CITY PLAN COMMISSION STAFF REPORT

Chatham Ave Self Storage

CD-CPC-2024-00199

Plan Conditions, Corrections, & Suggestions Report

SHEET
C108

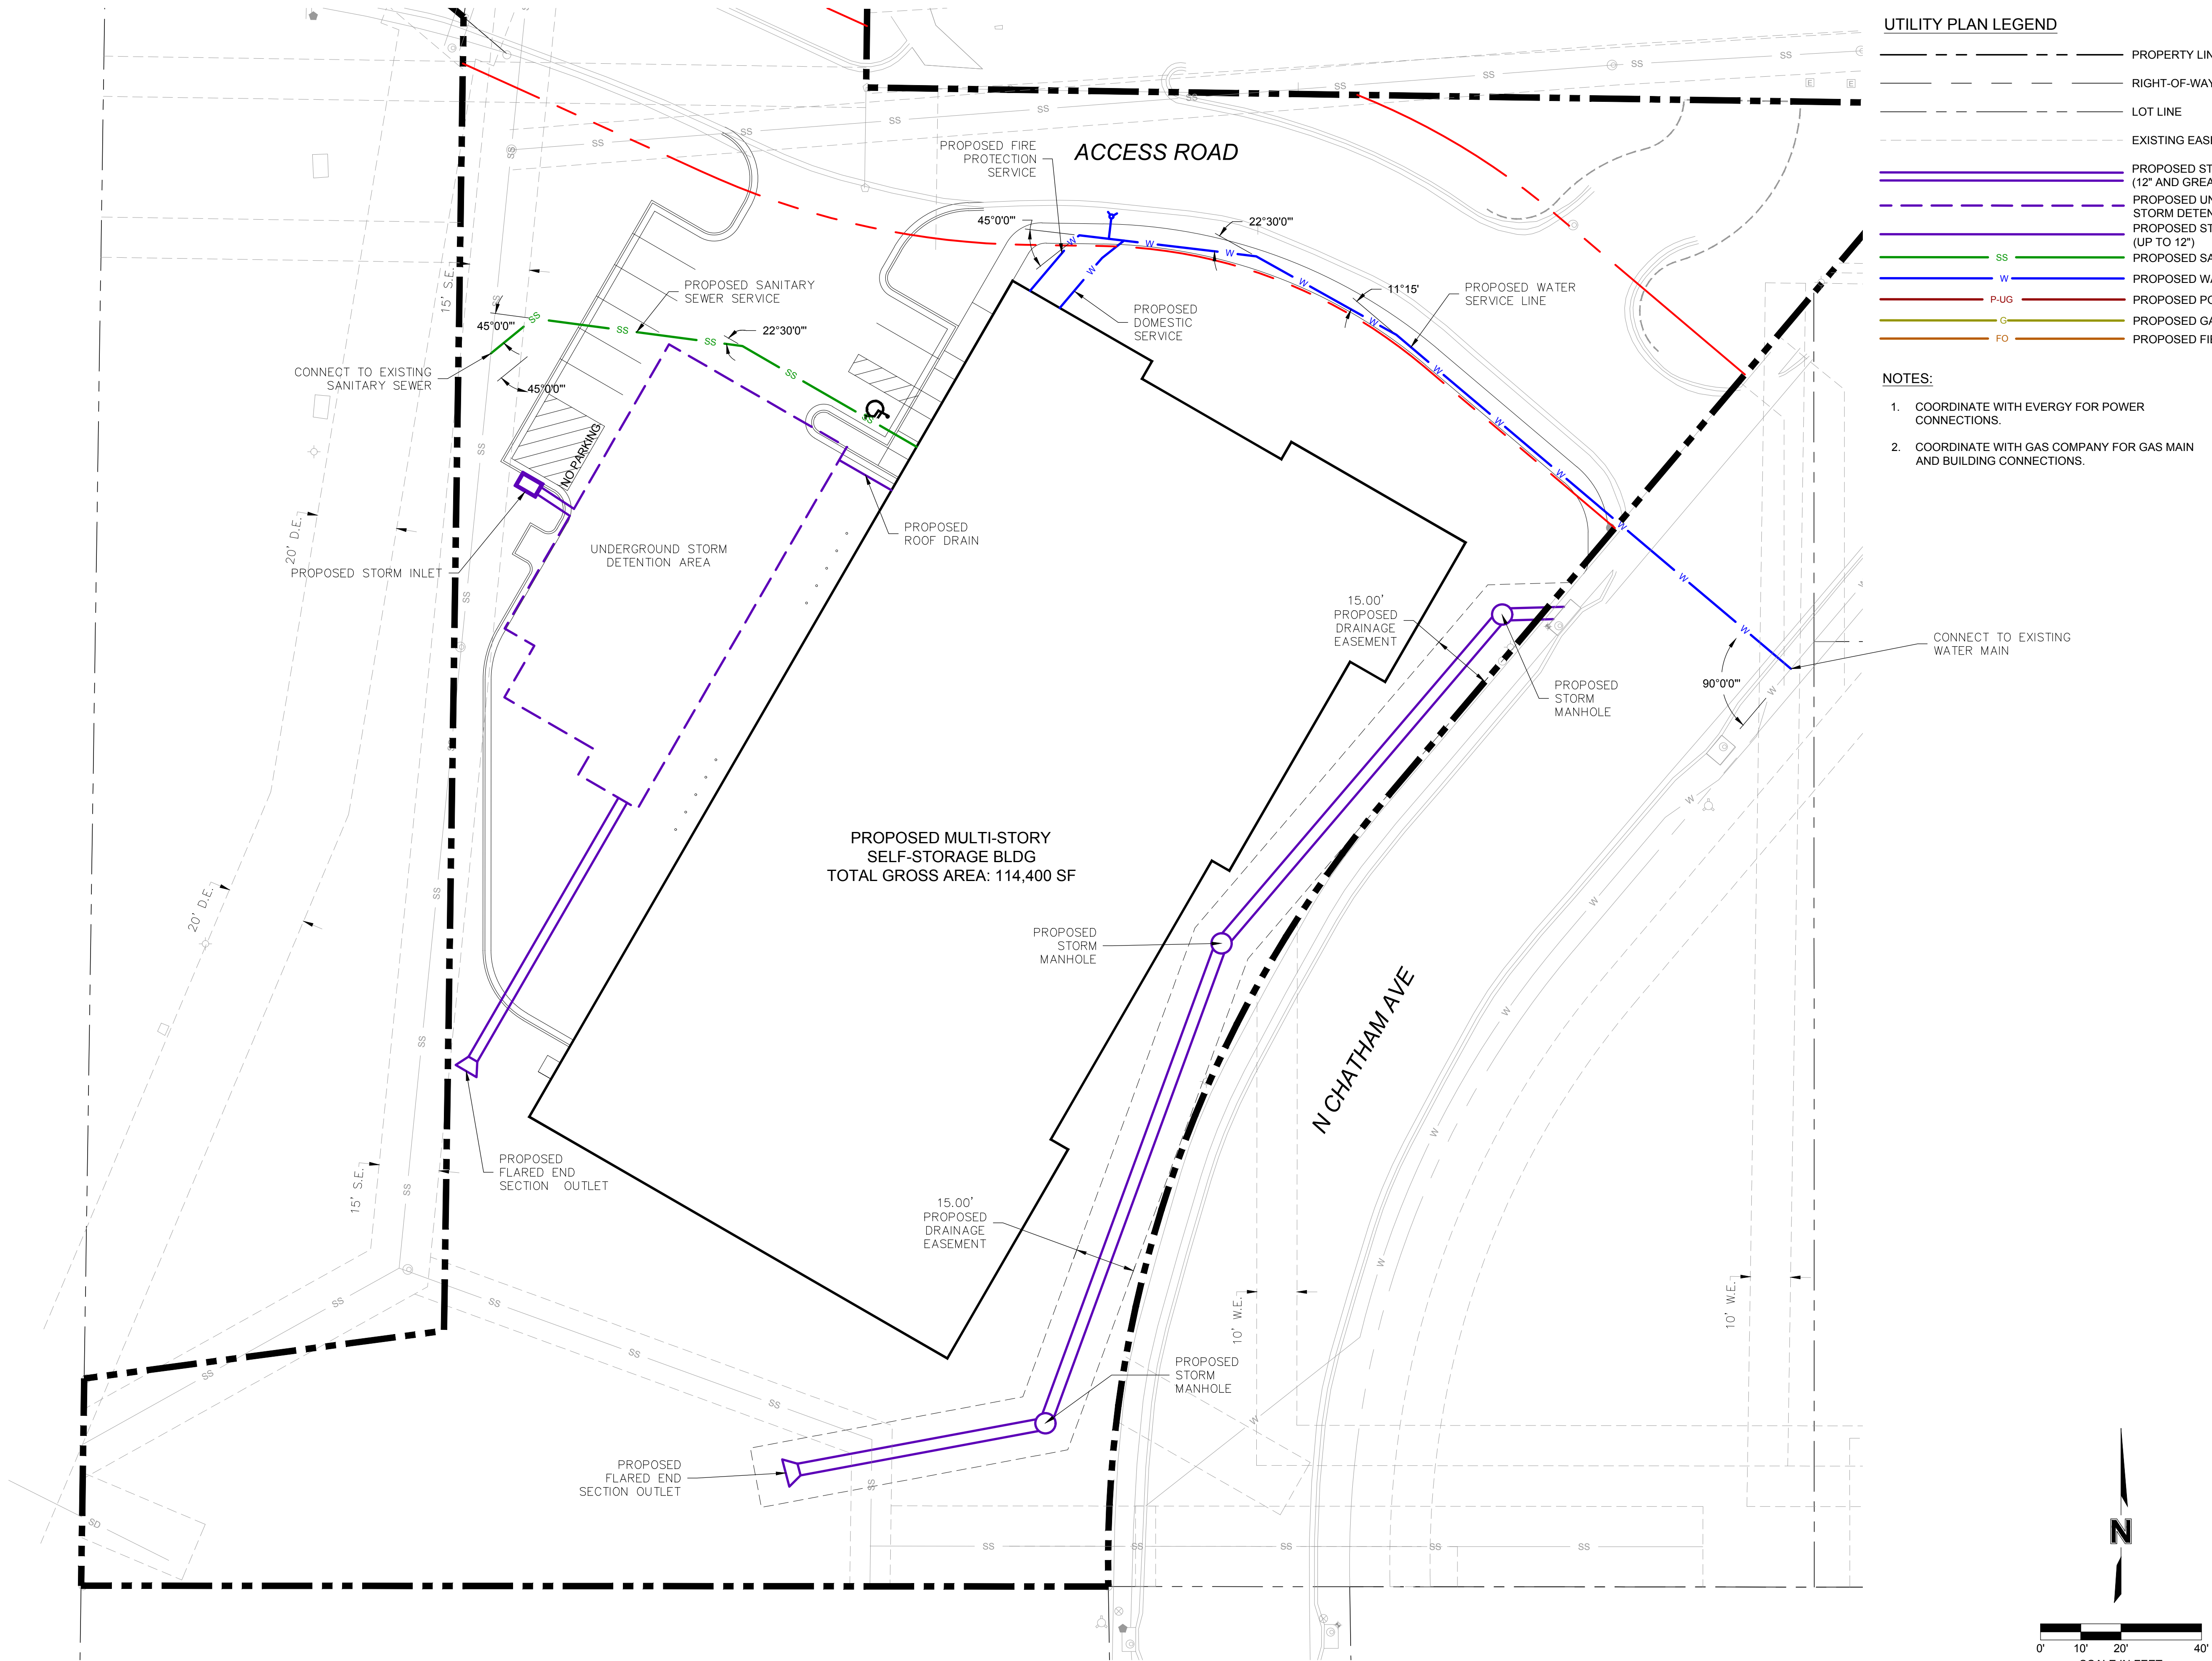
2. Street trees are required along N Chatham Ave. Revise Table 5. UPDATE 1/23/25: Street trees are required. Per 88-425-03-C(2) "Required street trees must be installed within the street right-of-way or within 10 feet of the street right-of-way. If street trees are to be located outside of the right-of-way, the city is authorized to require the establishment of a 15-foot landscape maintenance easement." If you can't fit the street trees in their required location, you still have to put them on-site within an easement. (1/21/2025)

4. Provide landscape plan prepared by a landscape architect in compliance with Section 88-425-12 of the Zoning and Development Code. Label proposed species under each category in the plant schedule. UPDATE 1/23/25: Replace Gold Lace Juniper, Siberian Spirea, and Japanese Yew with native plant varieties. (1/21/2025)

SHEET NAME:
BUILDING EXTERIOR
ELEVATIONS

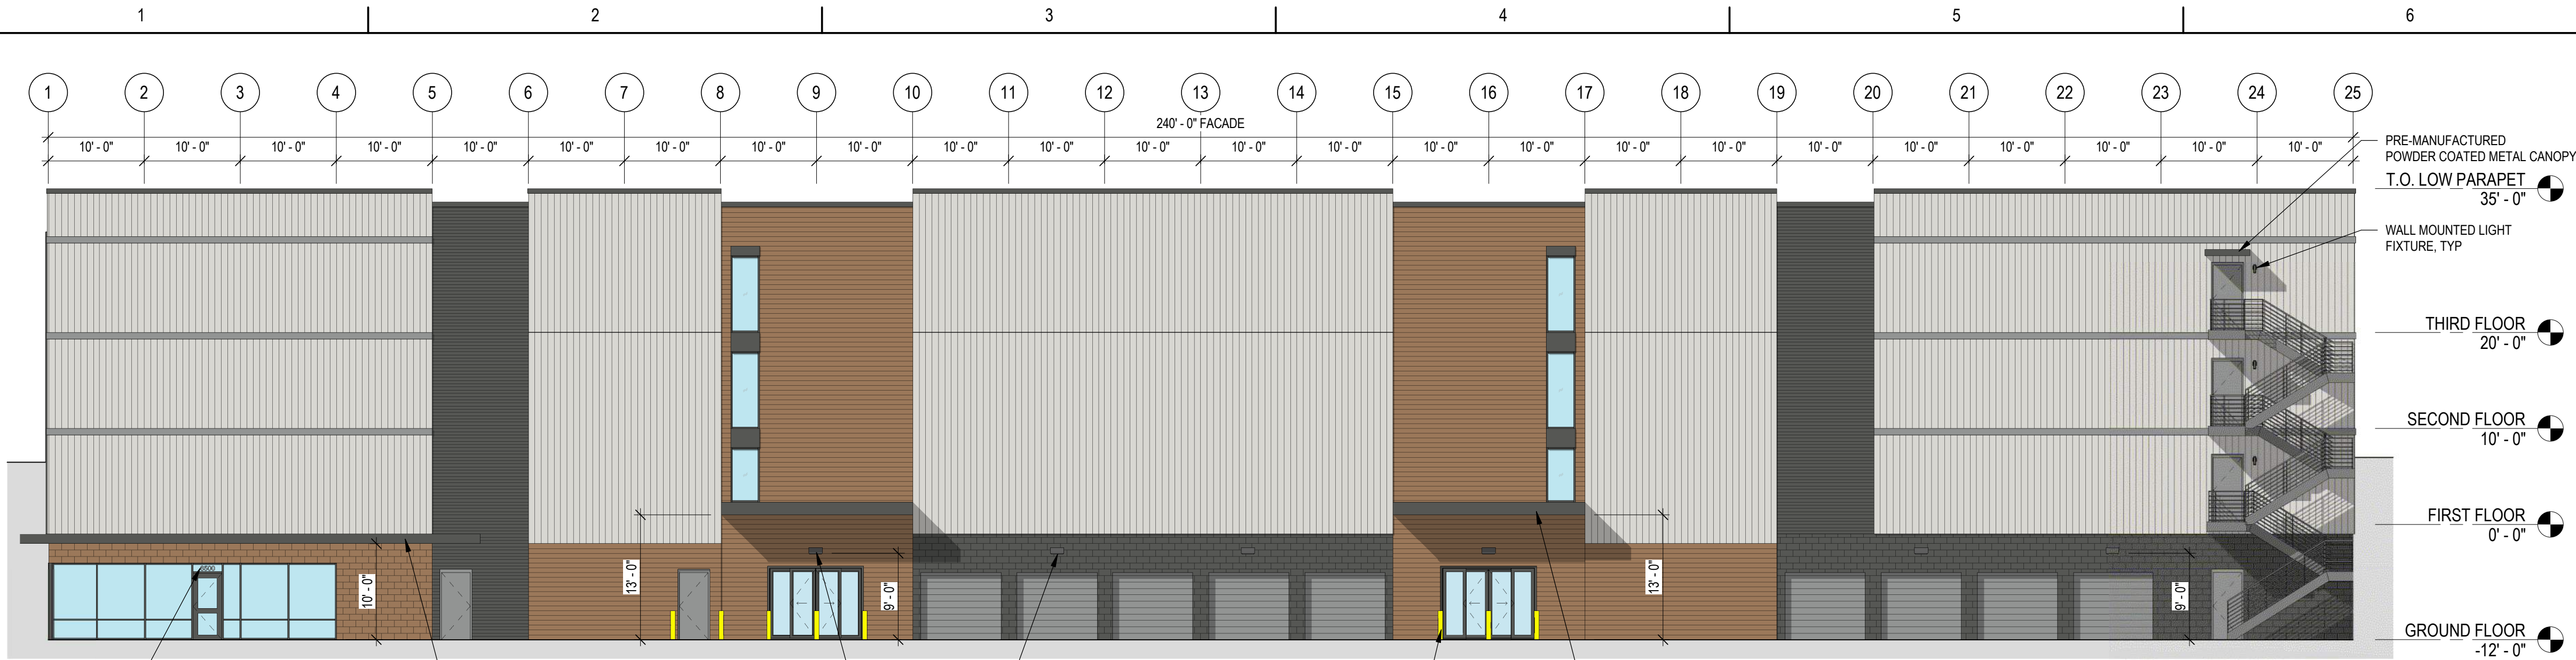
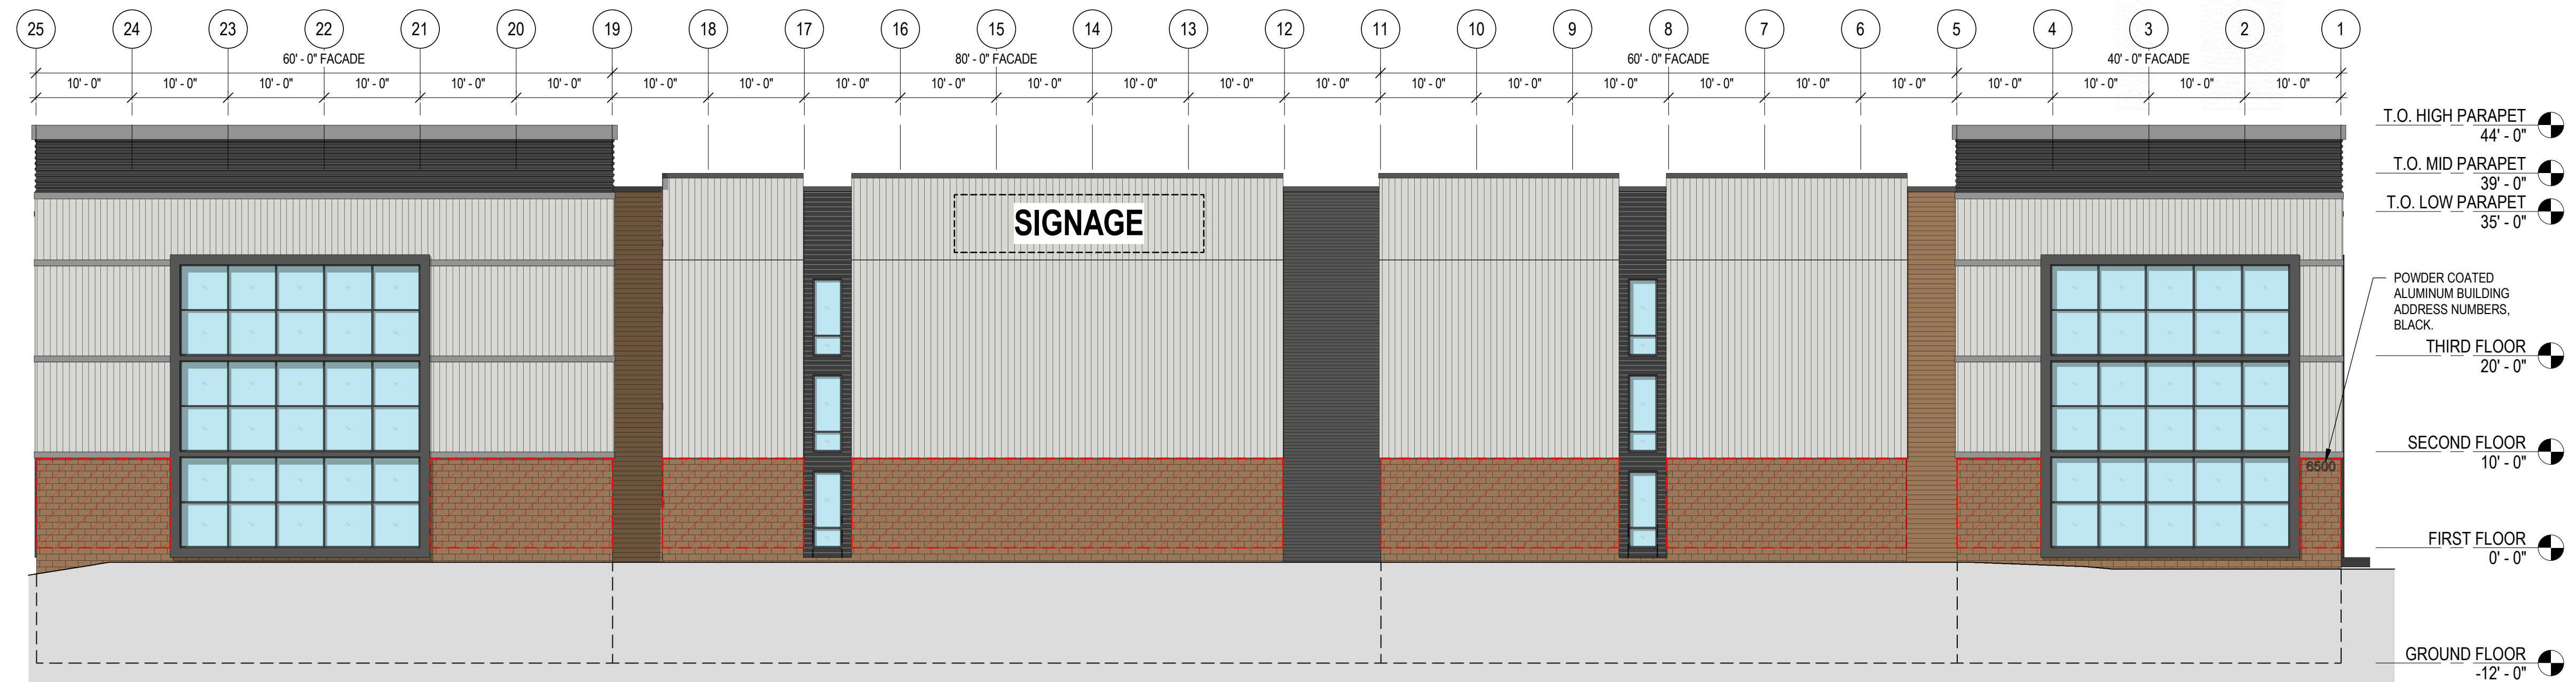
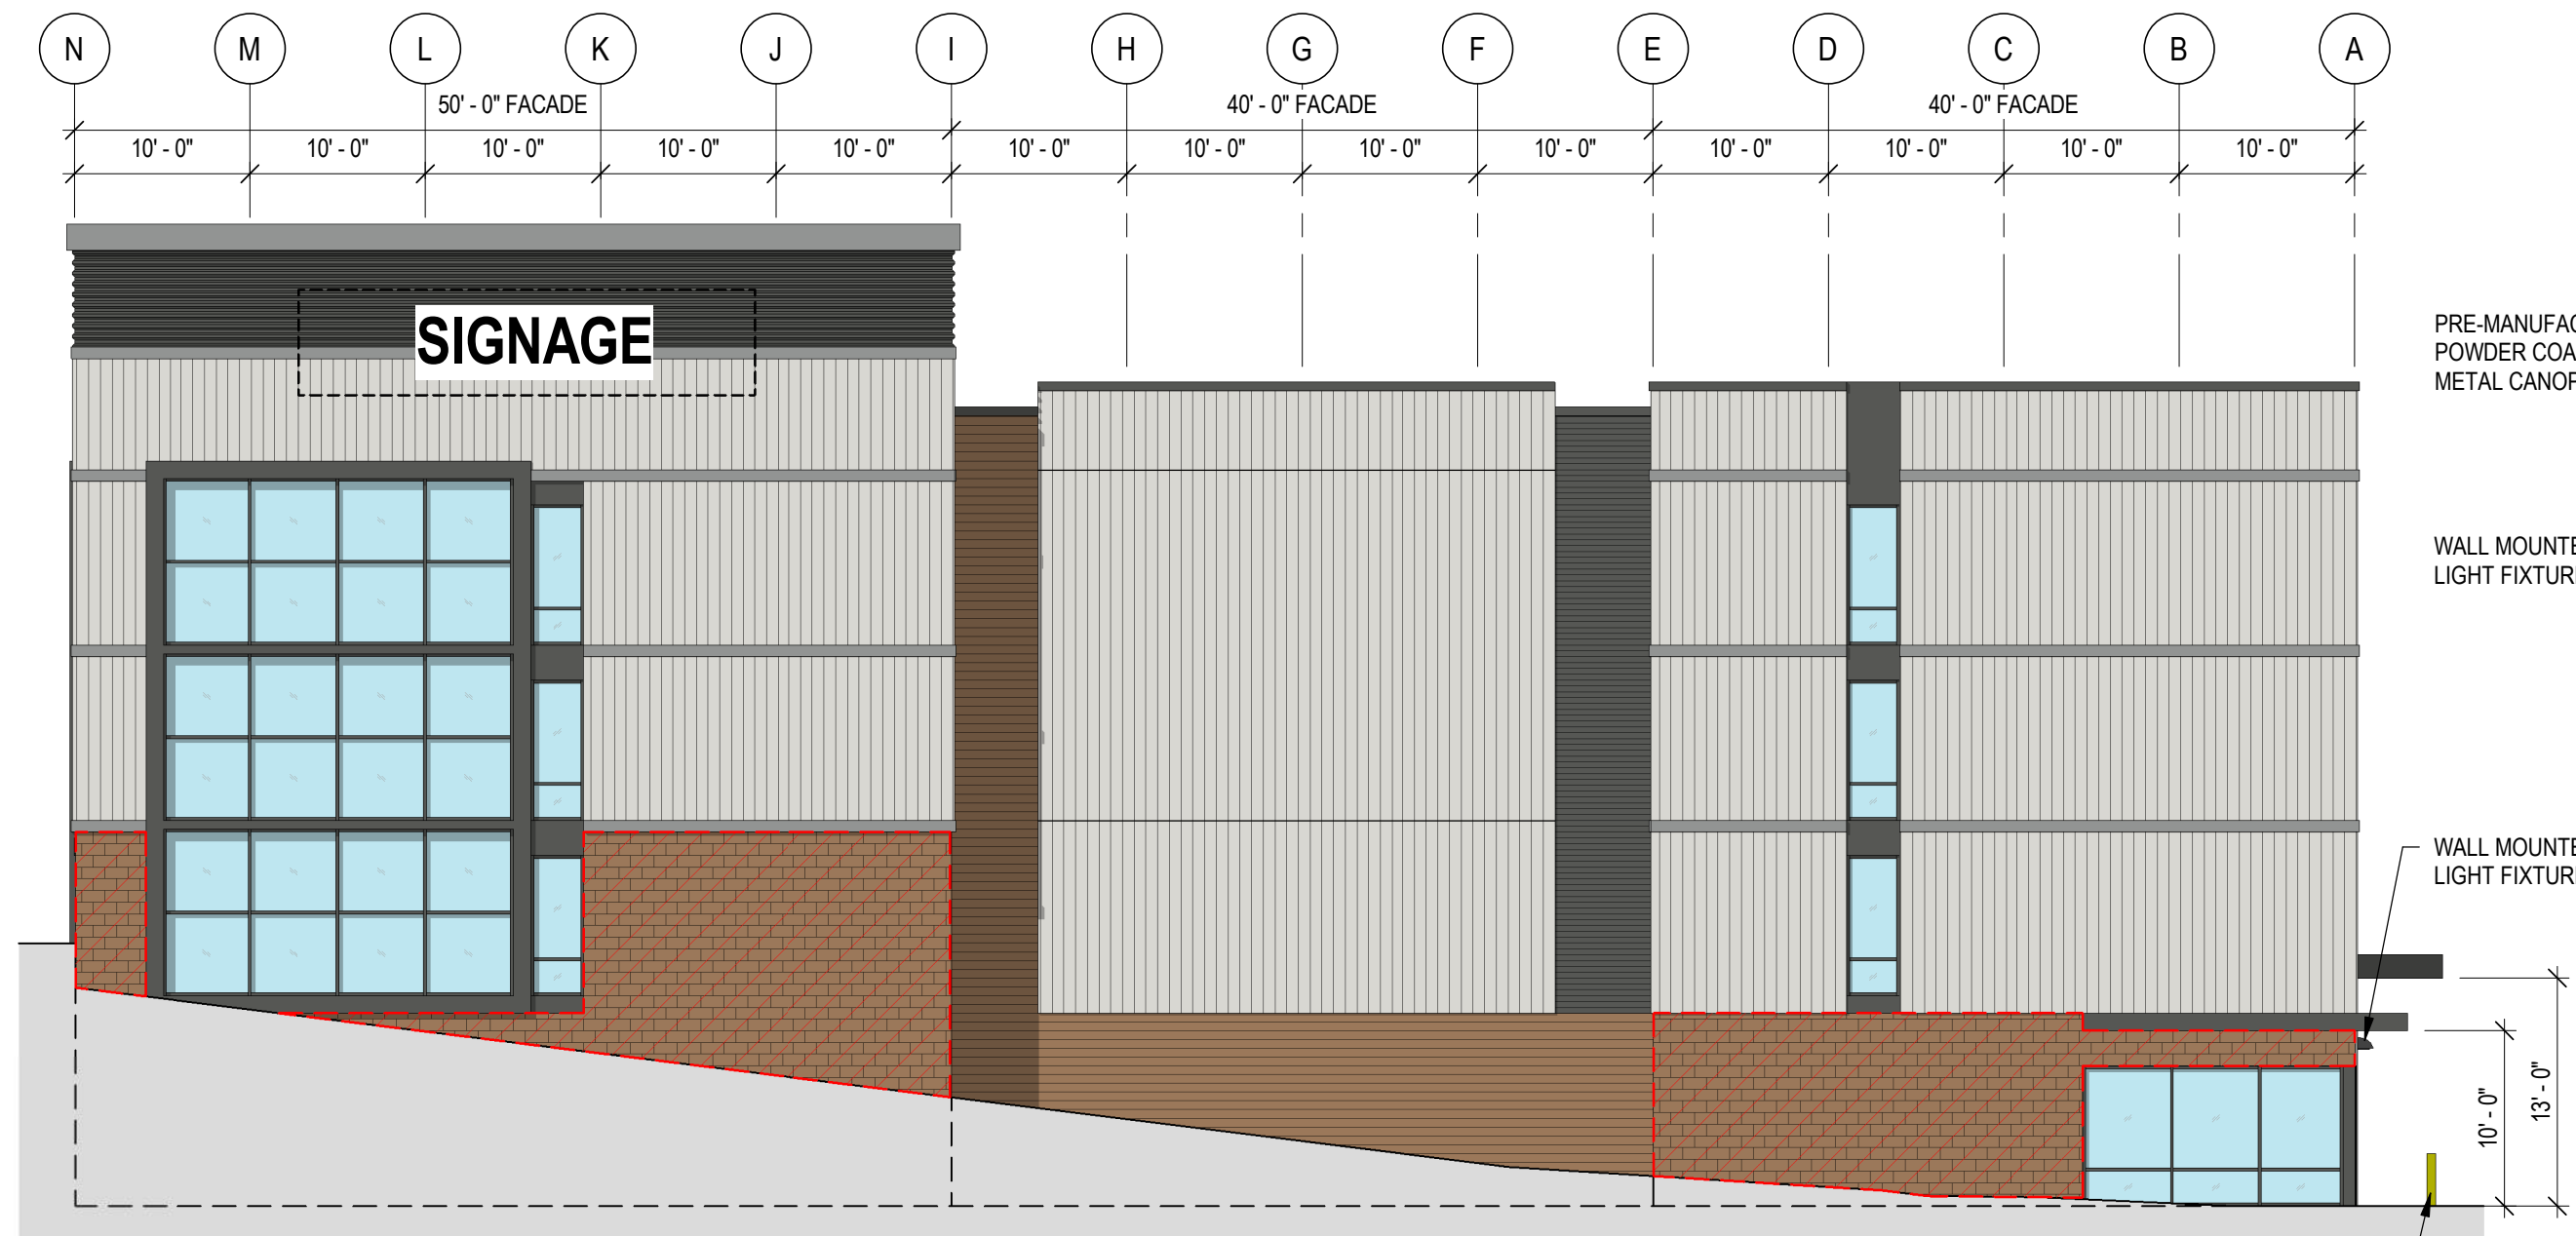
1. Per 88-369: Any wall abutting public right-of-way and over 75 feet in length shall include a combination of at least two of the following features: facade setbacks, change of building materials, varied roof line, a water table, or pilasters. Indicate which 2 features utilized on elevation sheets. UPDATE 1/23/25: Couldn't locate any notes identifying 2 of the above features on the plans as stated in the response letter. (1/21/2025)
